1 3.0 RESPONSES TO COMMENTS

2 Copies of the written comments that were submitted on the Draft EIR are provided in
3 this section, as well as excerpts of the transcripts from the public hearings held on
4 June 3, 2009 and June 4, 2009 (the complete transcripts are in Appendix J). Each
5 numbered Comment Set is immediately followed by the corresponding responses.
6 Comment letters are presented chronologically, in the order dated or that the
7 California State Lands Commission (CSLC) received the comment, followed by the
8 comments received during the public hearings. The comments received by the
9 CSLC during the public review period on the Draft EIR and at the public hearings
10 were reproduced in a Final EIR that was circulated to the public on July 27, 2009.
11 The same comments received by CSLC during the public review period on the Draft
12 EIR and at the public hearings are reproduced in this Revised Final EIR along with

13 responses to comments. The Revised Final EIR shows changes made to the
14 response to comments since release of the Final EIR on July 27, 2009, as underline
15 for new text, and ~~strike-out~~ for deleted text. In addition, the Revised System Safety
16 an

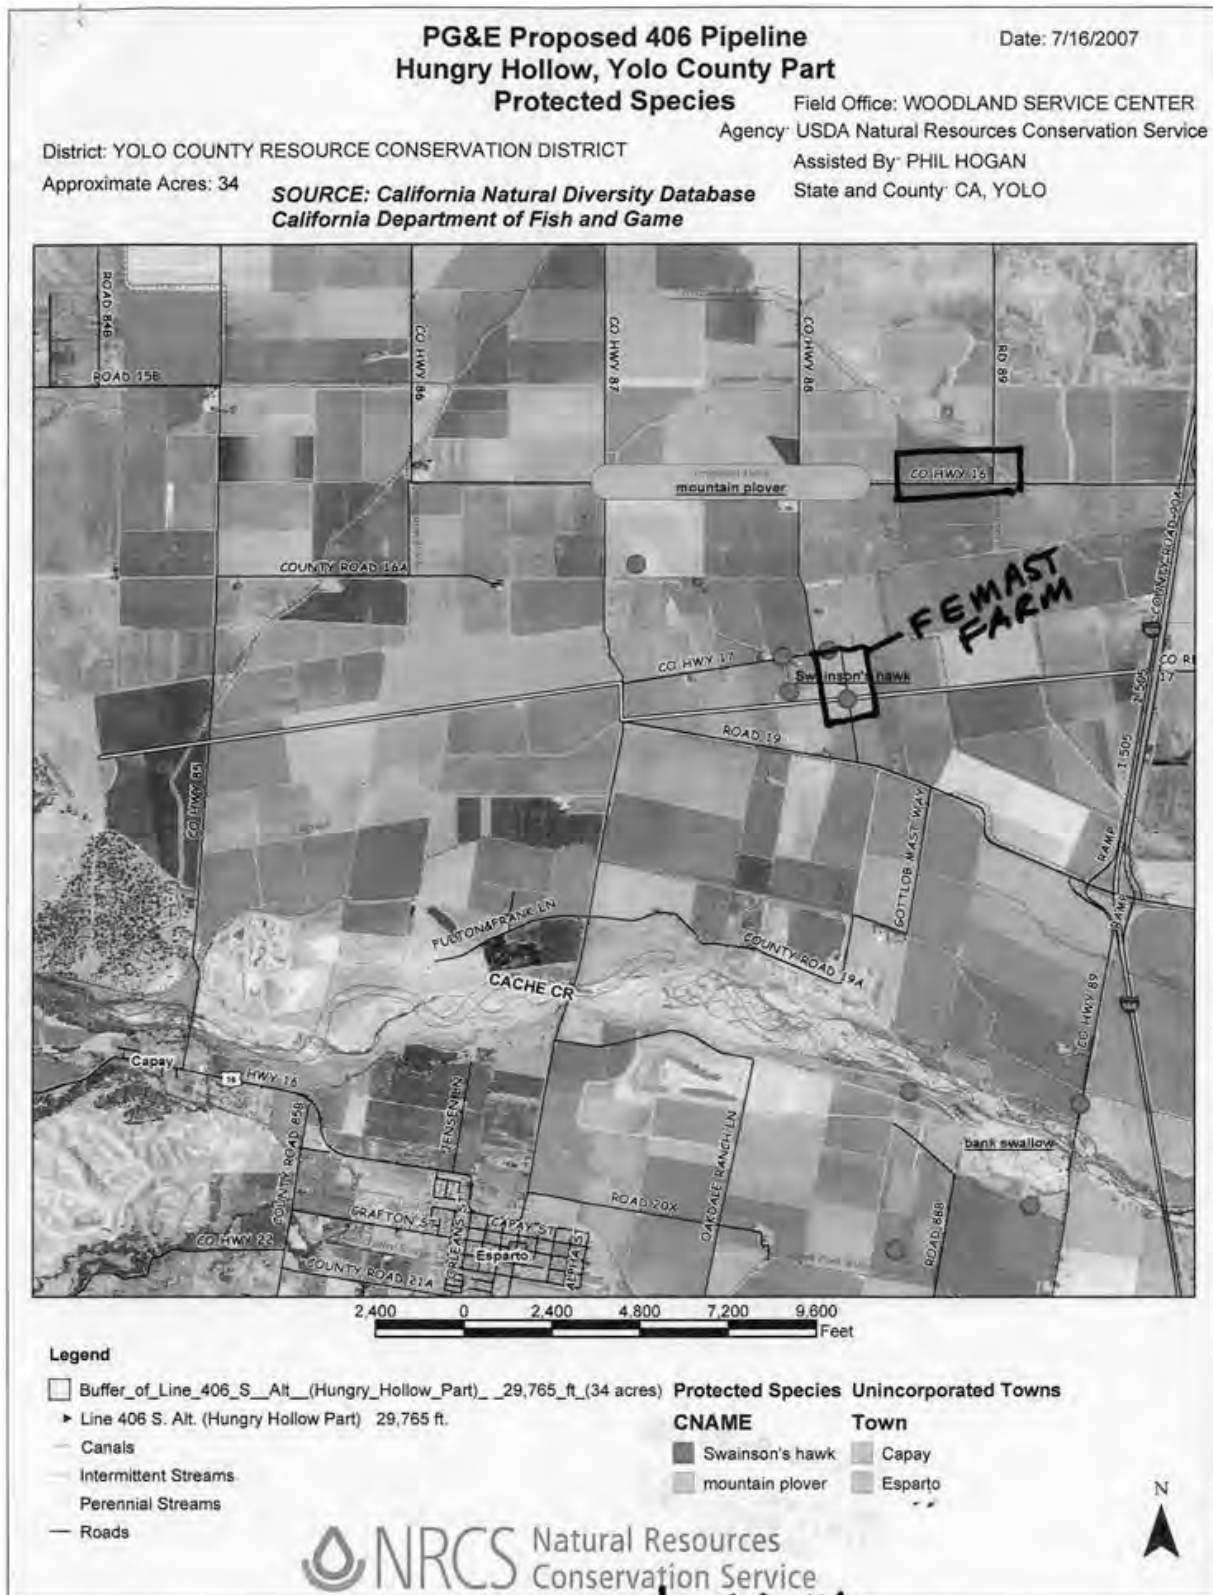
2. **Option A.** This would follow existing County Road 16 to I-505. See Figure 3-2B, Map 3. The pipeline would run **along the boundaries of agricultural fields, not through them.** There are almost no structures or trees along CR 16. Under Option A there is only 1 residence located within 200' of the pipeline, whereas 8 residences would be located within 200' of the pipeline for the proposed project. **Option A would cause the least impact on homes and agricultural cropland.** F-9

3. **Option F.** This would following existing CR 17 and then jog North through the Dunnigan Hills. The route would run along CR 17 instead of bisecting fields. See Figure 3-2E, Map 1. **Under Option F no houses would be within 200' of the pipeline.** ↓

4. **Option B.** The route would follow CR 16, and then turn South to cross I-505. See Figure 3-2B, Map 4. **This route results in 2 miles less bisecting agricultural lands.** This is a sparsely populated area and no residences are located within 200' of the proposed pipeline.

In looking at PG&E's proposed route, it is clear that it is a "straight shot" through cropland for purposes of keeping its cost as low as possible. Please do not permit that to happen, as there are very viable alternate routes which run along existing county roads, particularly CR 16 which is little used and has only 1 structure and few trees. Aesthetic impact to CR 16 would be de minimus.

27 **F-9** Section 3.0 of the Draft EIR evaluates a number of alternative options
28 along the proposed pipeline alignment to reduce or avoid one or more impacts of the
29 proposed Project. This comment expresses a preference for the No Project
30 Alternative, Option A, Option F, Option B, Option E, and Option D, in that order.

CONCEPTUAL LAND USE PLAN

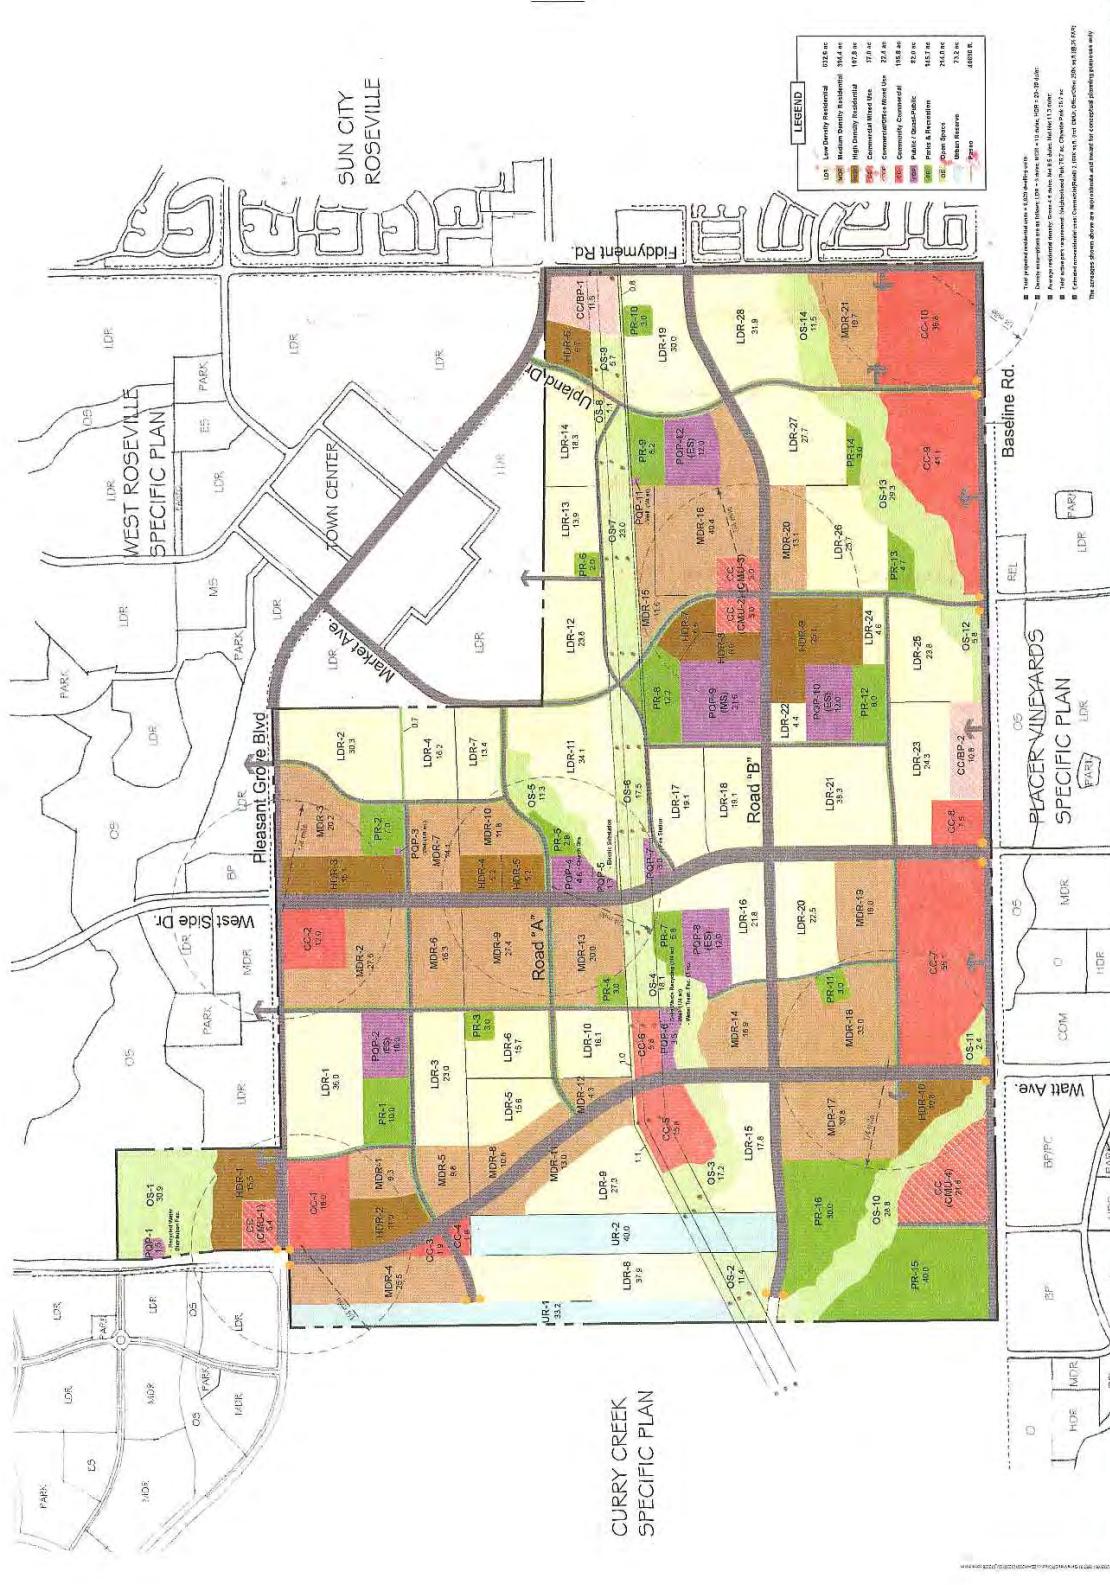
Since proposing Sierra Vista in 2005, extensive planning and engineering work has been conducted which is reflected in a refined land use plan (attached hereto as Exhibit 1). This land plan was prepared with input from the City, and also takes into consideration comments from various public agencies collected during an initial environmental review period.² The land plan locates sensitive uses near Baseline Road, including various public parks, residential, commercial properties and an elementary school site.
